Olympus reference: QIL FY25-EMEA-28-FY25-013 Guide Sheath Component**URGENT: FIELD SAFETY NOTICE****RE: Single Use Guide Sheath Kit****Attention:** Endoscopy Department, Bronchoscopy Suite, Pulmonology, Risk Management

REPLY FORM – QIL FY25-EMEA-28-FY25-013 Guide Sheath Component

Figure 1: Single Use Guide Sheath (models SG-200C and SG-201C)

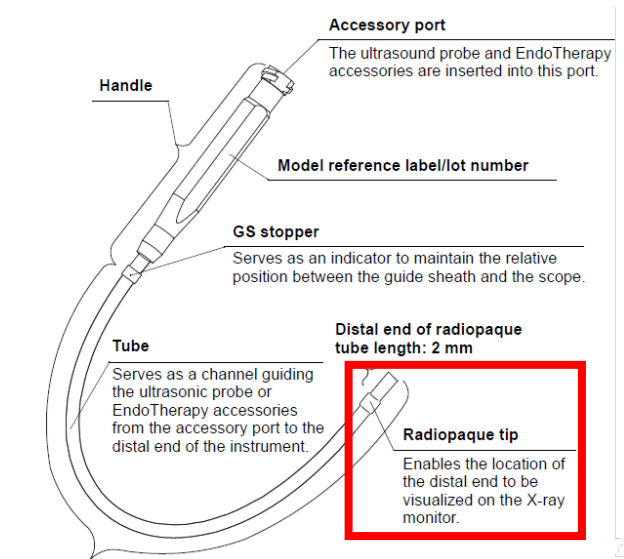
Olympus conducted an investigation into the Single Use Guide Sheath Kits after receiving complaints that the radiopaque tip of the guide sheath component (see Figure 1 below), fell off into the patient. Since July 2021, Olympus has received 32 complaints involving intraoperative disassociation of the guide sheath radiopaque tip in which the tip fell off into the patient. Of these 32 complaints, 26 were reported as serious injuries, and 6 were reported as malfunctions. The preliminary findings from Olympus' investigation have identified that the disassociation of the tip from the guide sheath is likely the result of excessive force applied when inserting instruments into the guide sheath, and/or damage to the distal end of the sheath.

Olympus has launched the next generation of the Single Use Guide Sheath Kits, models K-401, K-402, K-403, and K-404, which has a different radiopaque tip design. Therefore, Olympus has discontinued the previous generation models (K-201, K-202, K-203, and K-204) and is removing these models from the market.

You should stop using the K-201, K-202, K-203, and K-204 Single Use Guide Sheath Kits as soon as possible. The next generation Single Use Guide Sheath Kits, models K-401, K-402, K-403, and K-404, should be used by your facility instead.
